ADDENDUM NO. 01

CITY OF PORT ARANSAS CITY HALL / CIVIC CENTER EXPANSION AND RENOVATION

TRA PROJECT NO. 2023-29

Issue Date: March 11, 2025

ALTERNATE 02 - INTERIOR
ELEVATIONS & BUILDING
SECTIONS - AREA 'B'

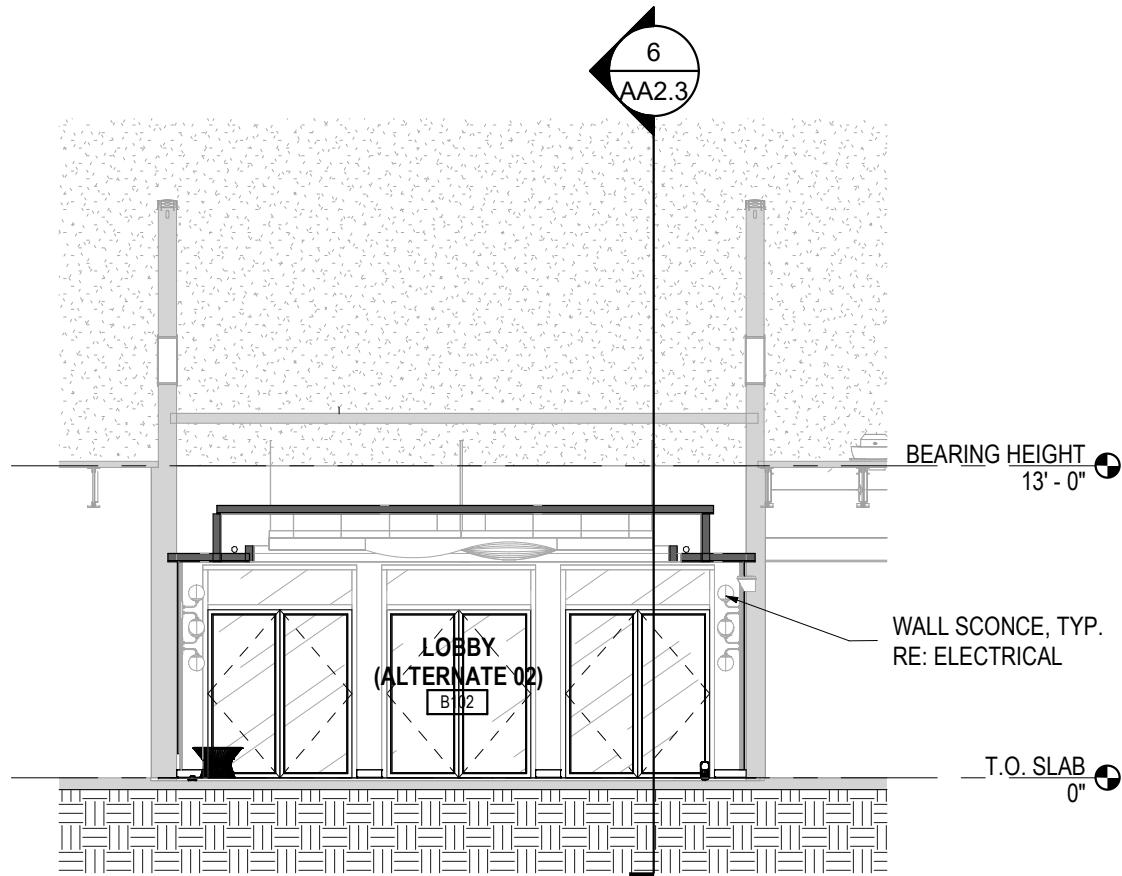
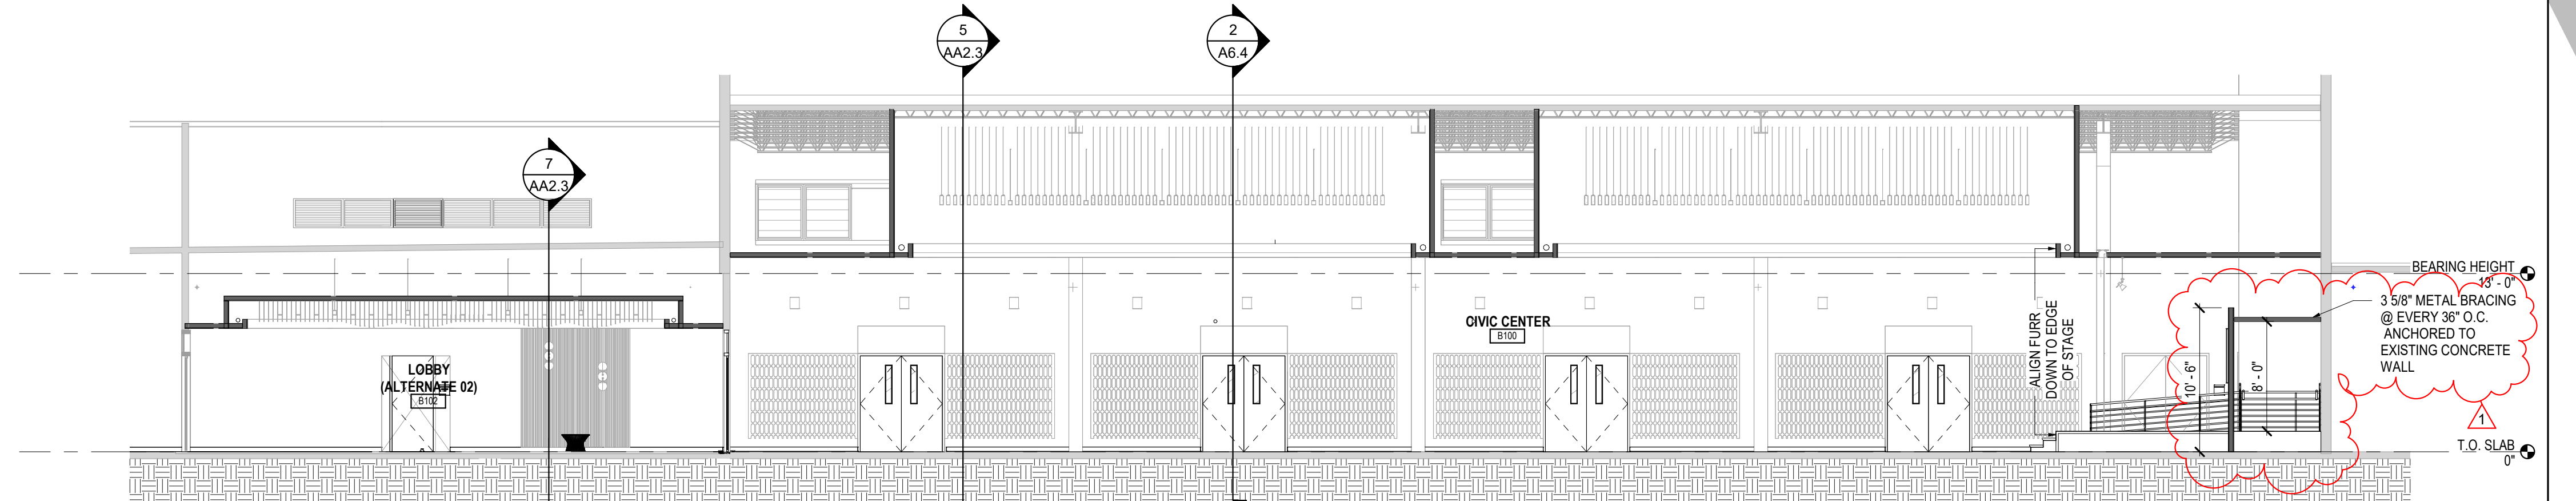
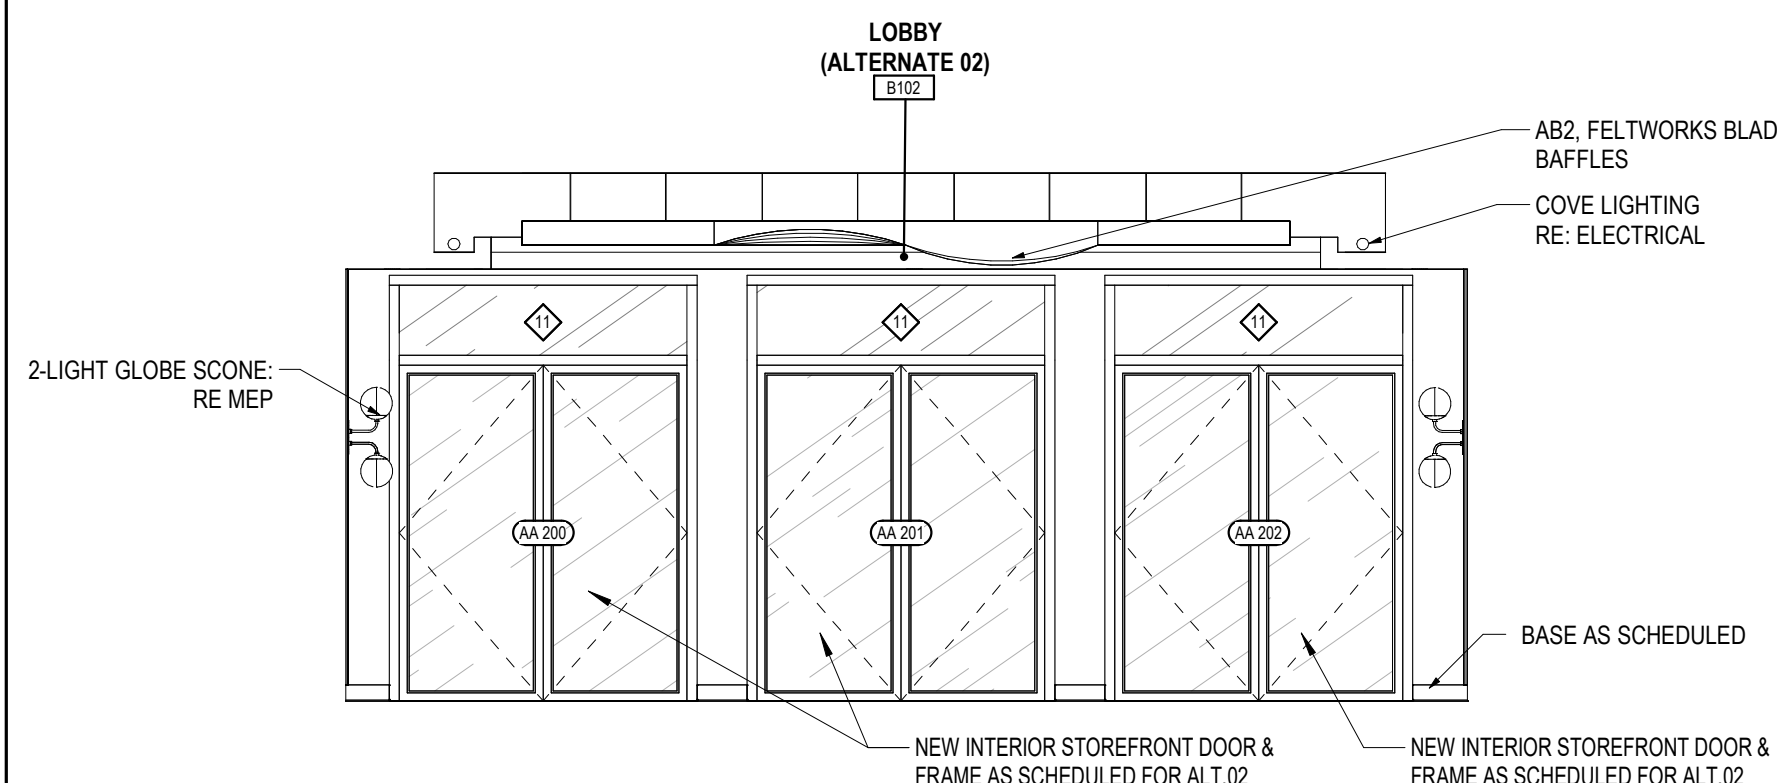
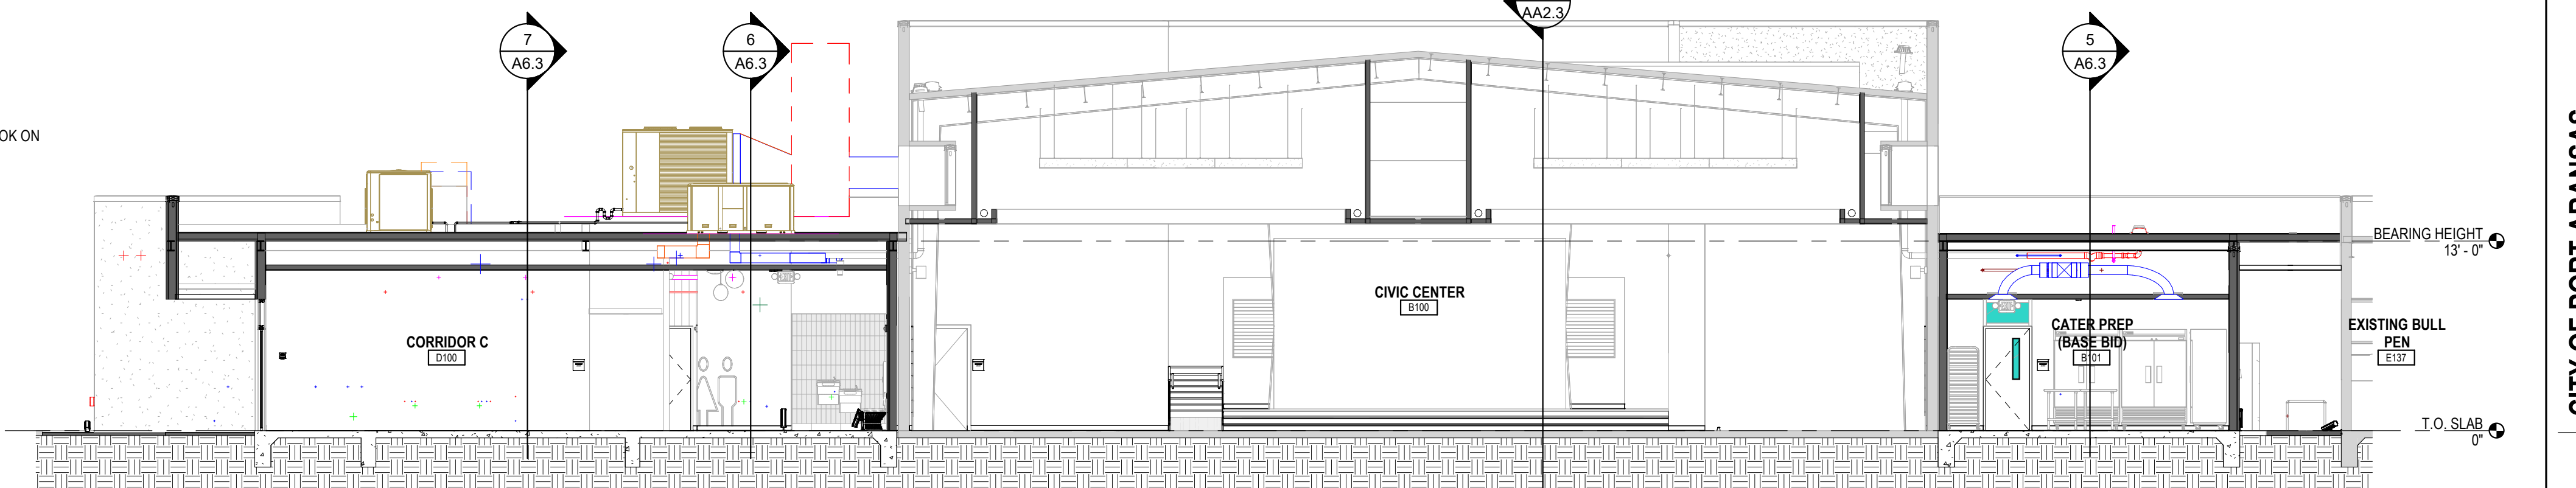
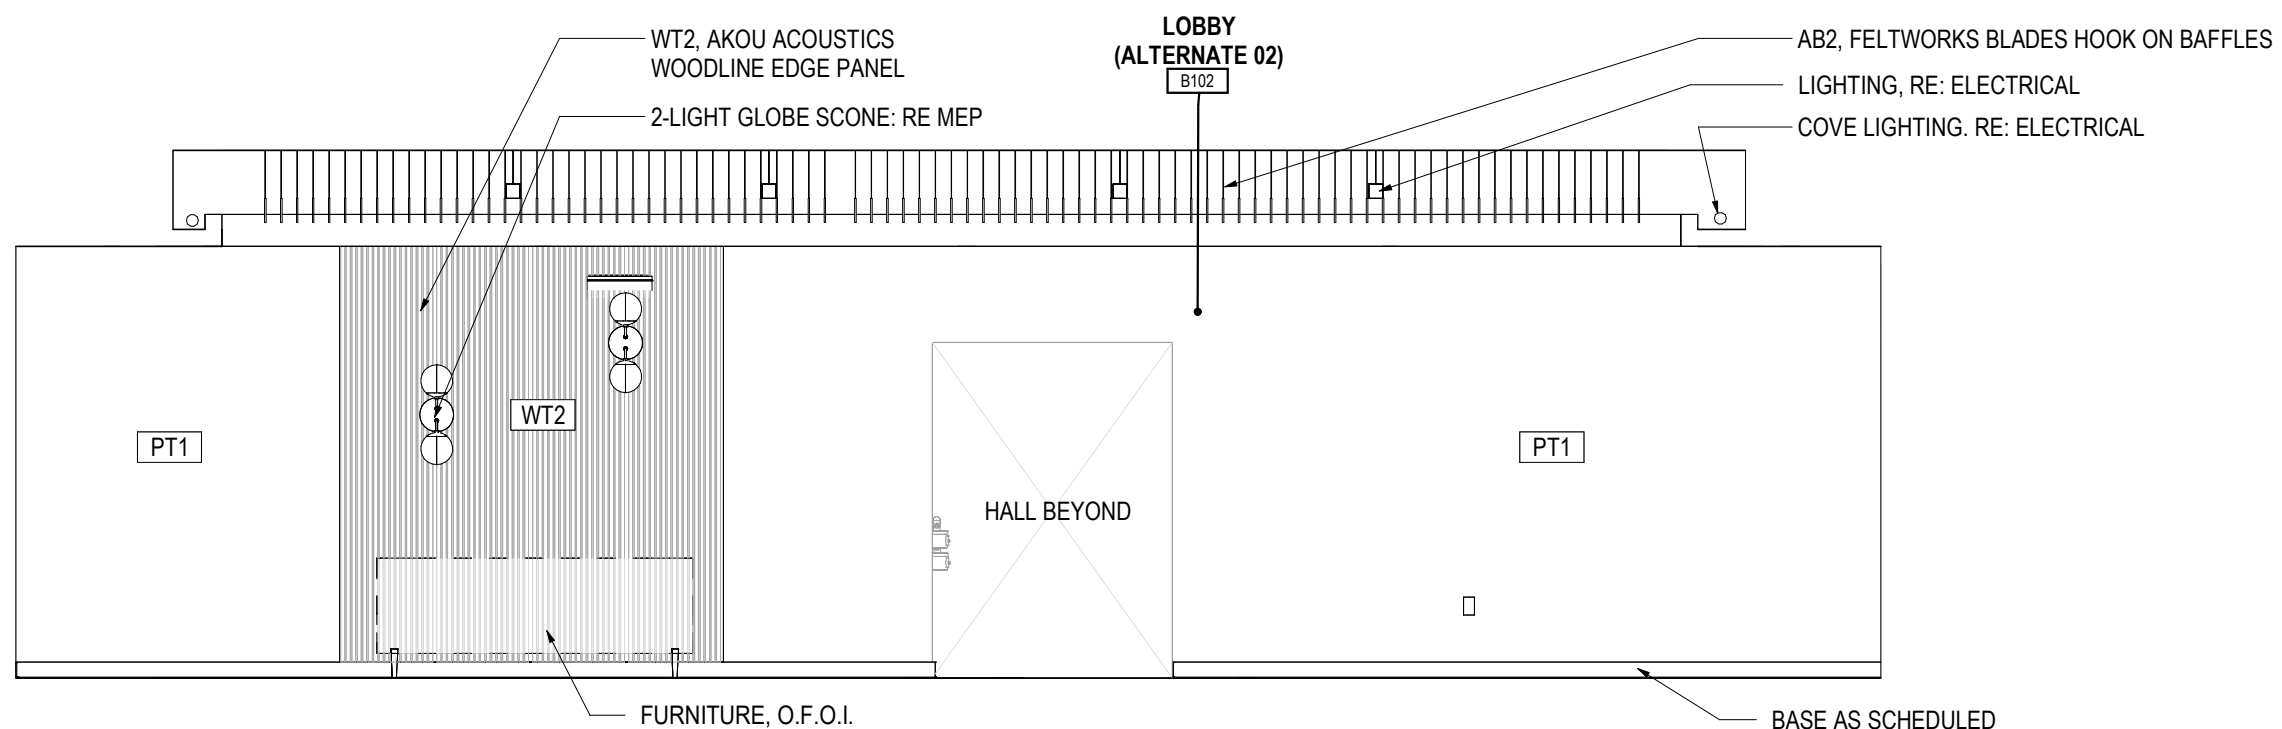
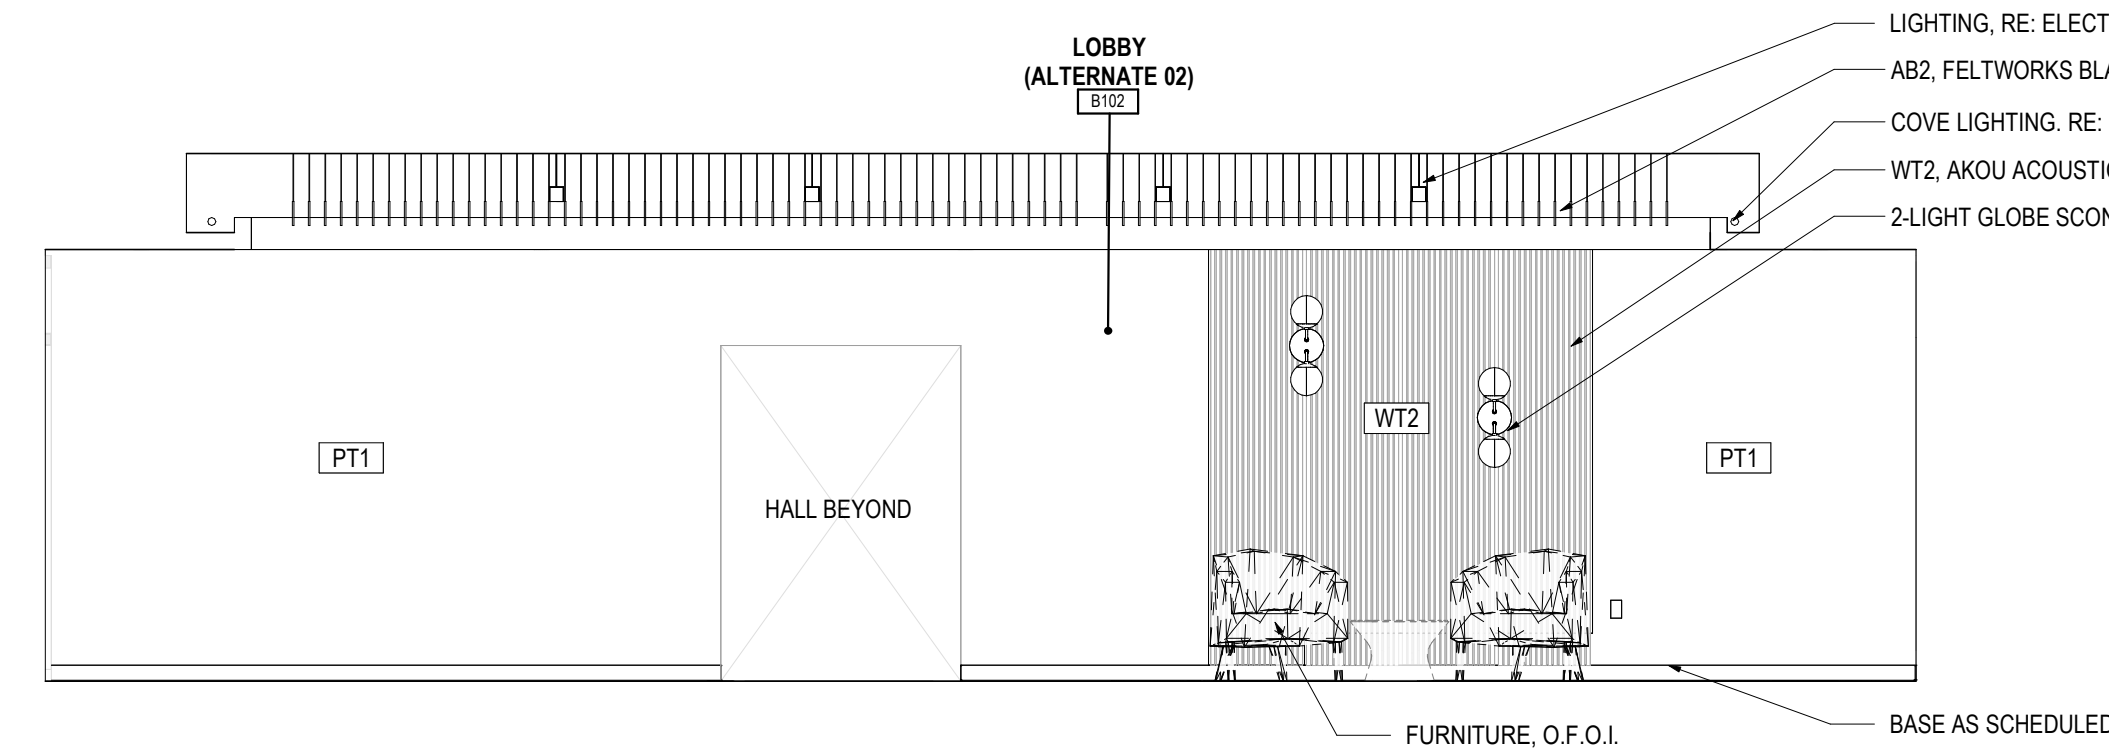
- DESCRIPTION:** 3-5/8” metal bracing at stage wall.
- ITEM NO. 38:** **DRAWING SHEET AA3.0 – ALTERNATE 03 – DOOR & WINDOW LOCATIONS**
- Remove, in its entirety, Drawing Sheet AA3.0 – Alternate 03 – Door & Window Locations and REPLACE with the attached Drawing Sheet AA3.0 – Alternate 03 – Door & Window Locations, sealed 02/21/25; revised 03/11/25.

ALUMINUM FRAMES ALT. 03

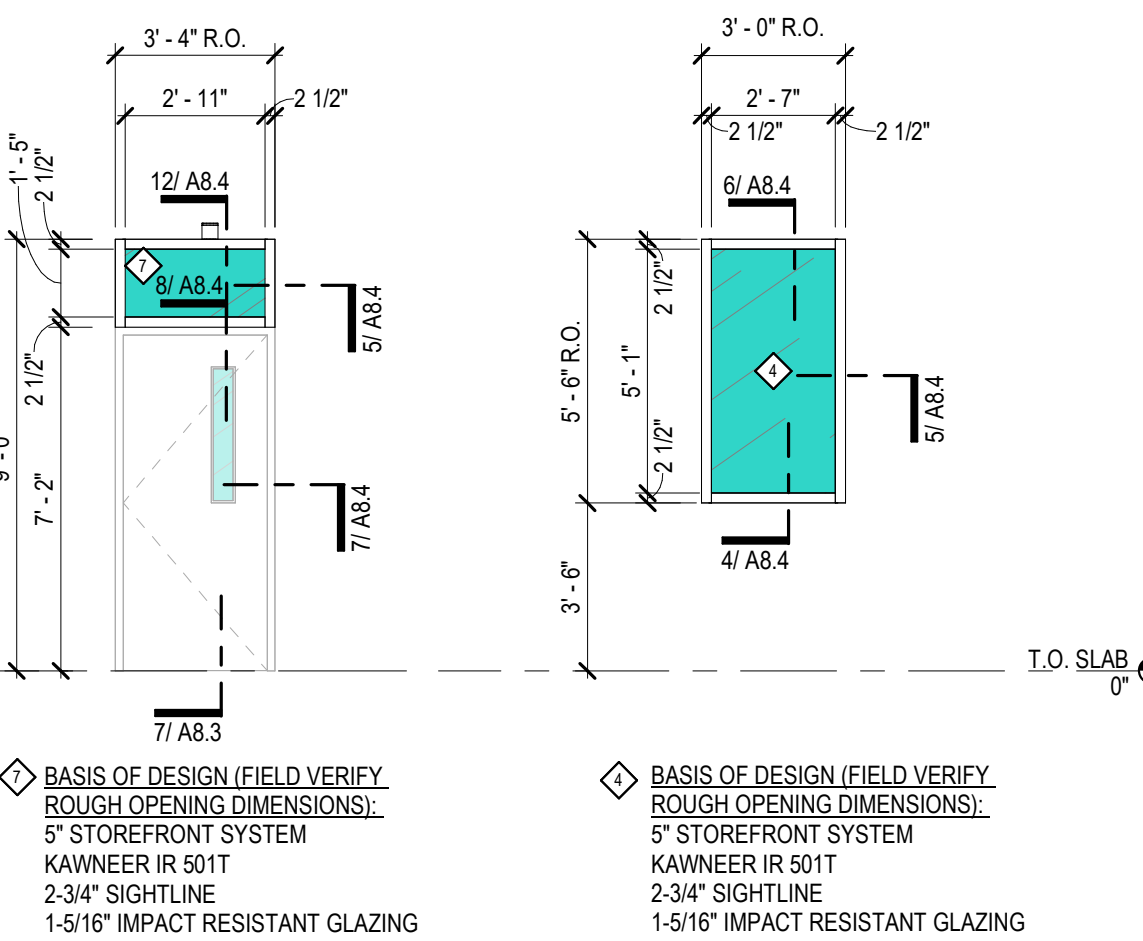
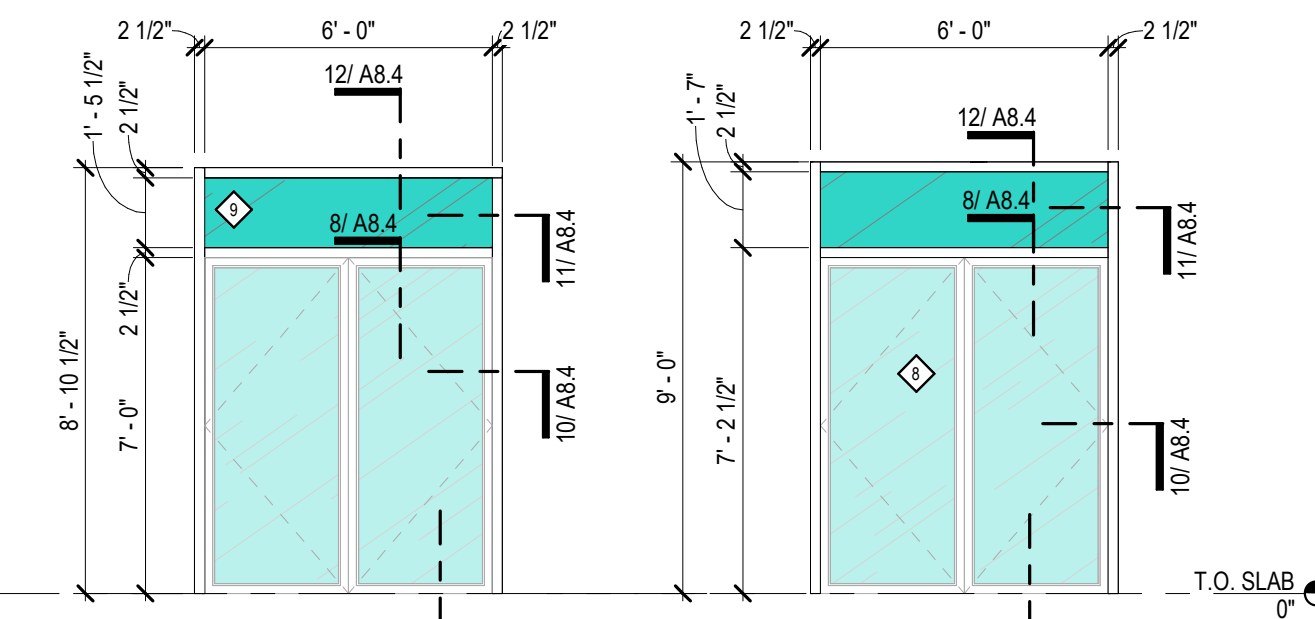
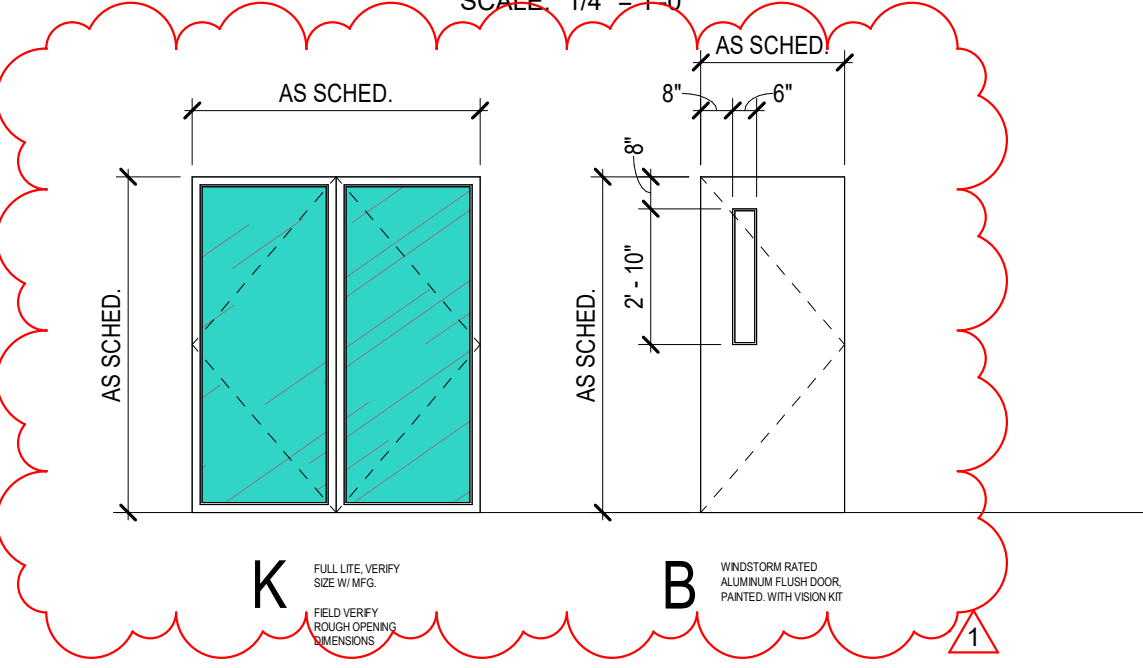
Q4: Alternate #3 – Sheet AA3.0

- DOOR AA309: Door is listed as hollow metal, framing is listed as aluminum and elevation is listed as IR50T exterior aluminum storefront. Please confirm basis of design for this door and frame.
- DOOR AA306, AA307, and AA308: Doors and framing are listed as hollow metal but elevation is marked as elevation 8 which indicates IR501T exterior aluminum storefront. Please confirm basis of design for these doors and frames.

- DESCRIPTION:** Doors AA306, AA307, AA308, and AA309 to have Door Panel Type B – Windstorm Rated Aluminum Flush Door, Painted with vision kit.
- ITEM NO. 39:** **DRAWING SHEET M1.3 – MECHANICAL FLOOR PLAN – CITY HALL (ALTERNATE #1)**

RESPONSE: Refer to Door Schedule.
